ASHLAND PLANNING COMMISSION

PLANNING ACTION: PA-T2-2024-00053
SUBJECT PROPERTY: 231 Granite Street
PROPERTY OWNERS: Stephanie & Bryan DeBoer
APPLICANTS: Carlos Delgado Architect
DESCRIPTION: A request for a Physical and Environmental (P&E) Constraints permit to construct a new single-family dwelling in steep slopes greater than 25% within the hillside overlay area, including exceptions to the hillside design standards. The proposal includes a Type 2 variance due to the proposed driveway grade exceeding 18%. The applicant also requests a tree removal permit to remove 67 trees, 63 of which are between 6" and 12" Diameter at Breast Height (DBH), 8 of which are dead, and 4 are significant trees which are larger than 12" DBH. **COMPREHENSIVE PLAN DESIGNATION:** Low Density Residential; **ZONING:** RR-.5; **MAP:** 39 1E 08 DA; **TAX LOTS:** 1800

RE: **APPLICANT FINAL WRITTEN ARGUMENT/REBUTTAL**
Planning Action: PA-T2-2024-00053
Applicants: Bryan & Stephanie DeBoer
Subject Property: 231 Granite Street (39-1E-08DA, Tax Lot 1800)

Subject: Rebuttal Regarding Planning Action PA-T2-2024-00053: 231 Granite St.

AS1.1

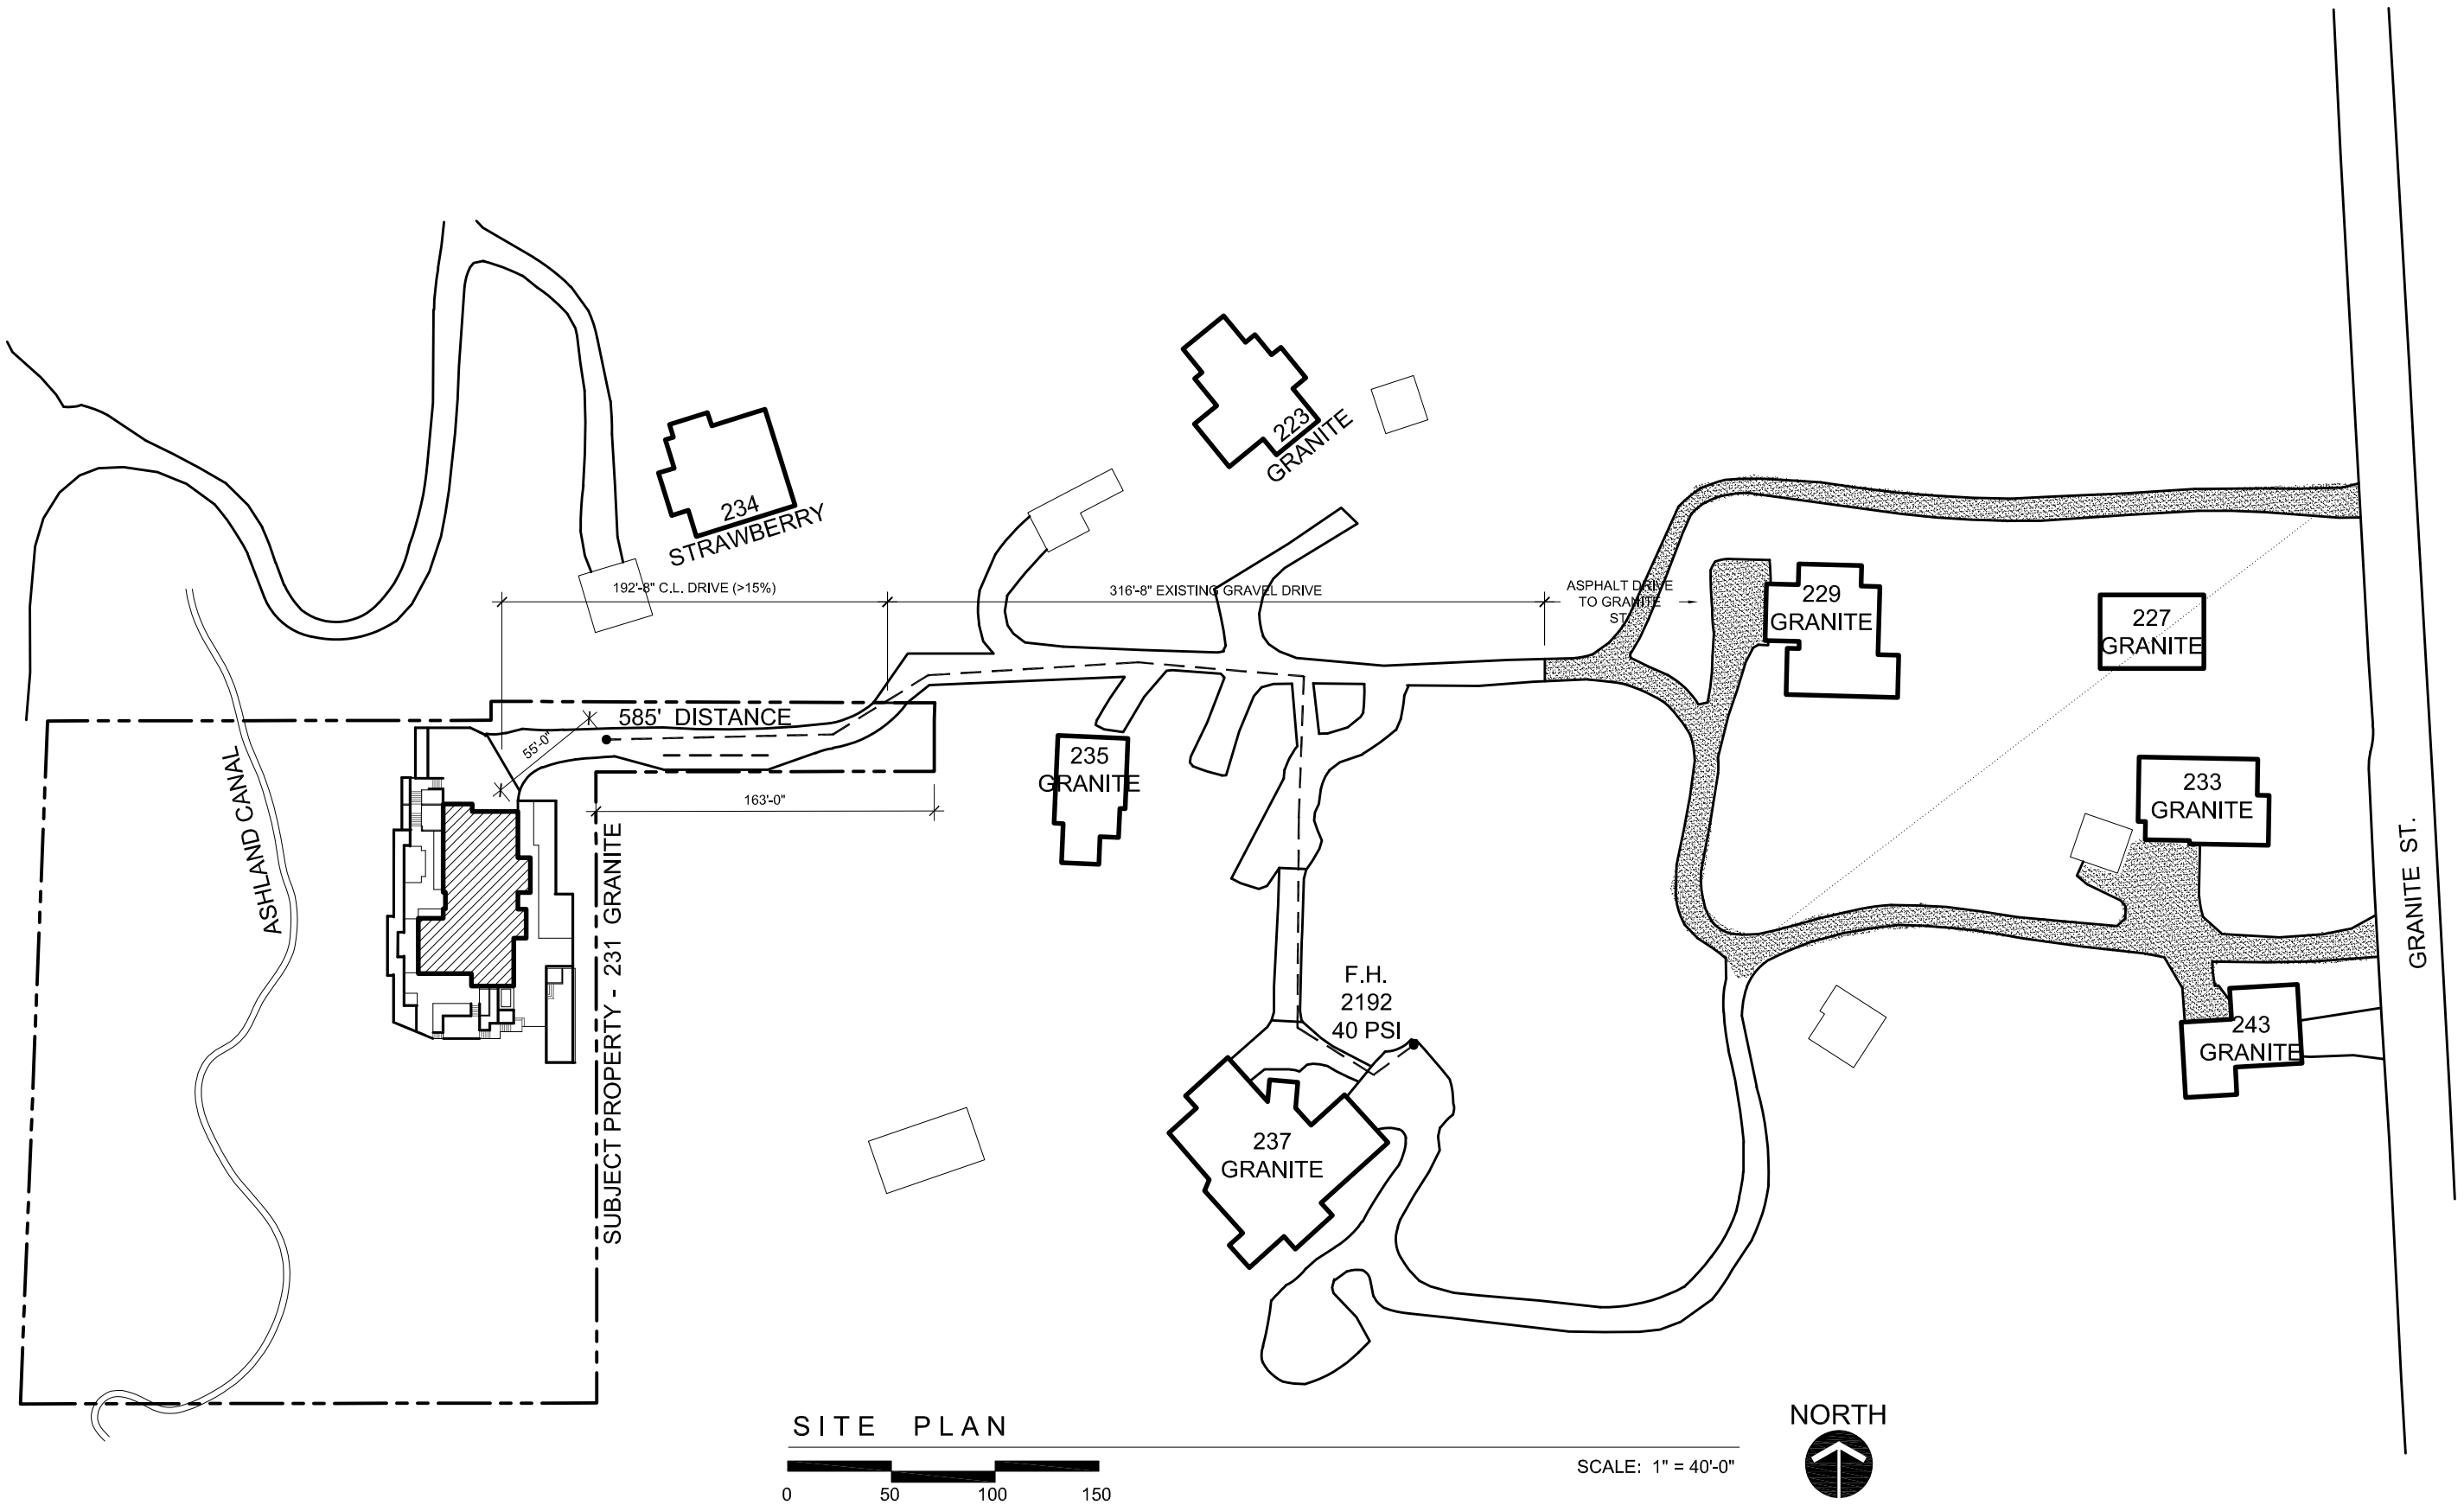
The proposed driveway length on the subject property is 183 feet and 223 feet to the edge of the existing gravel-surfaced driveway. This existing and proposed driveway exceeds 18 percent and exceeds 200 feet in length. The requested variance for the required access to the property is not only for the grade but the maximum length of the allowed grade. A graphic of the entire driveway has been provided on attached Sheet AS1.1., AS1.2., and on the Civil Sheet (C1).
